Cobalt Geosciences, LLC
P.O. Box 1792
North Bend, WA 98045

RE: Plan Review & Comment Responses
Proposed Additions/Remodel
5320 Butterworth Road – CAO25--011
Mercer Island, Washington

UPDATED

SITE MAP
FIGURE 1

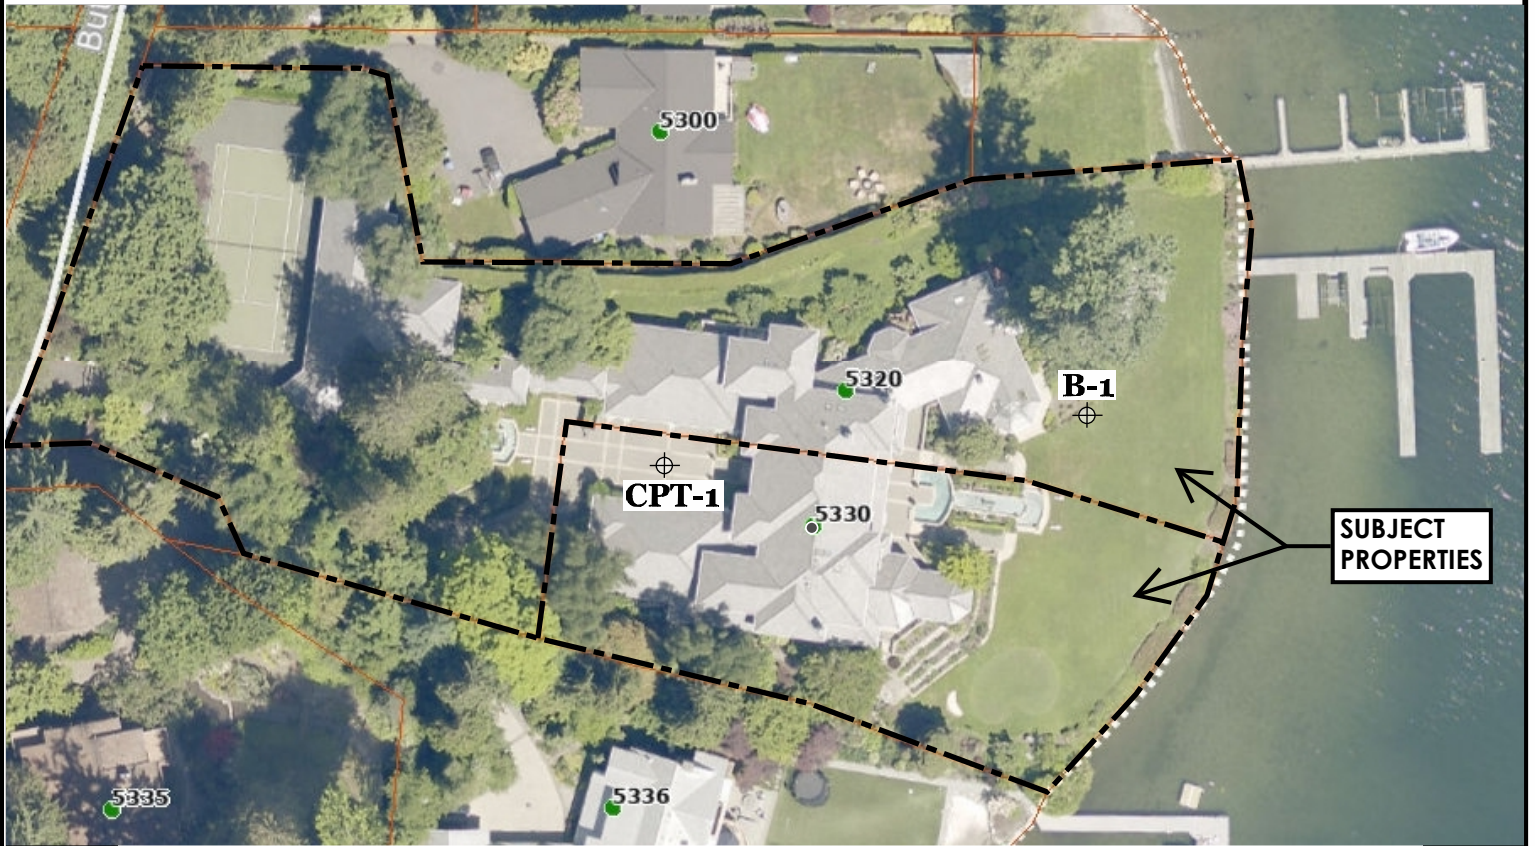
There are comments regarding structural design and how it relates to potential lateral spread, ground loss, and structural deformation.

We recently advanced a Cone Penetrometer Test boring (CPT) in the driveway at the site. This log is attached with seismic information and soil behavior. To summarize, the boring encountered areas of fine grained soils within the upper 12.5 feet which were locally loose. Minor interbeds of these soils were present near 20 and 23 feet below grade. All other soils were mostly coarse grained with gravels and became consistently dense about 12.5 feet below grade. Very dense soils were encountered consistently below 34 feet with refusal.

We analyzed the risk of lateral spread by the Bartlett and Youd method (1993). We determined a 1.45 kilometer distance between the site and Seattle Fault Zone from the DNR boring database and relevant thickness of soils with an N value of 15 or less (average), grain size, and slope between the property and Lake Washington.

As noted in this letter, we estimated lateral spread of about 6 inches for the design event. We re-analyzed lateral spread with varying values for the grain size, thickness of saturated soils and fines content. This is discussed in more detail on Page 3.

Based on these results, lateral spread is most likely to occur near the eastern margin of the residential structure, decreasing to the west and generally increasing to the east.

We discussed potential use of grade beams to resist or manage these movements. It is our opinion that interconnecting grade beam systems embedded 2 to 3 feet below grade and supported on piles is a suitable option to limit lateral issues to an acceptable level. It may be necessary to space grade beams at 10 or 15 feet on center in east-west and north-south directions through the structure and backfill between the grade beams with compacted structural fill. Triangular grade beam layouts are known to be useful in liquefiable or lateral spread susceptible areas.

The analyses yield an estimated 0.15 meters of lateral spread. This is about 6 inches of lateral movement. A mat foundation systems including interconnecting grade beams supported by pin piles could be utilized to resist lateral spread, if required. Battered piles may be an option but could result in some structural distress of the residence during/after certain seismic events.

We reanalyzed lateral spread with different values of T₁₅, F₁₅ and D₅₀₋₁₅ to determine potential worse case and best case lateral spread displacement. We note that the displacements ranged from 4 to 18 inches in the area of Boring B-1, relatively close to Lake Washington. Displacements from the interpreted soil conditions in the CPT boring yielded values of 2 to 9 inches of displacement. The displacements are more limited due to minimal sand thicknesses. It is our opinion that the grade beam system supported on pipe piles are suitable for the site and lateral spread displacements will not result in structural damage that threatens life safety.
